Product Change Notice (PCN)

PCN Number: PCN-65280402R-01

- VMS-300-x-y (x=12, 15, 24, 36, 48, 0512 or 1224; y=blank, CF or CFS) series
- VMS-300-Dx-y (x=12, 15, 24, 36, 48, 0512 or 1224; y=blank, CF or CFS) series

For U & CF type - Current terminal block-

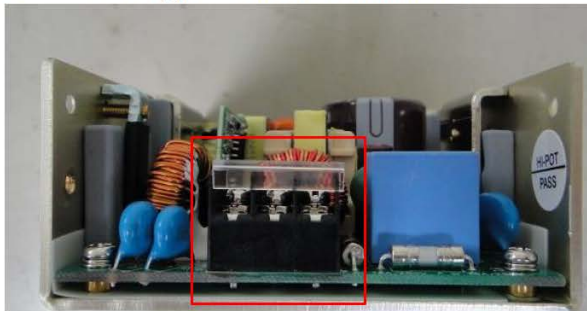
Description of Change: IEC 60601-1: 2005+ A1, EN60601-1: 2006+A11+A1+A12 requires input connector to have European approval (TUV, VDE or EN/EC etc.). The new connector, which meets European approval, does not have the plastic cover. See updates highlighted within Red squares in the images below:

New terminal block-

For CFS type - Current terminal block-

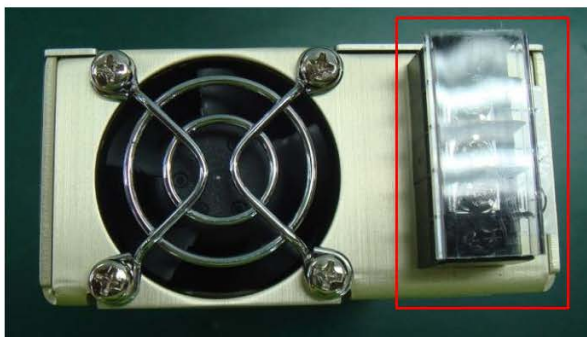
New terminal block-
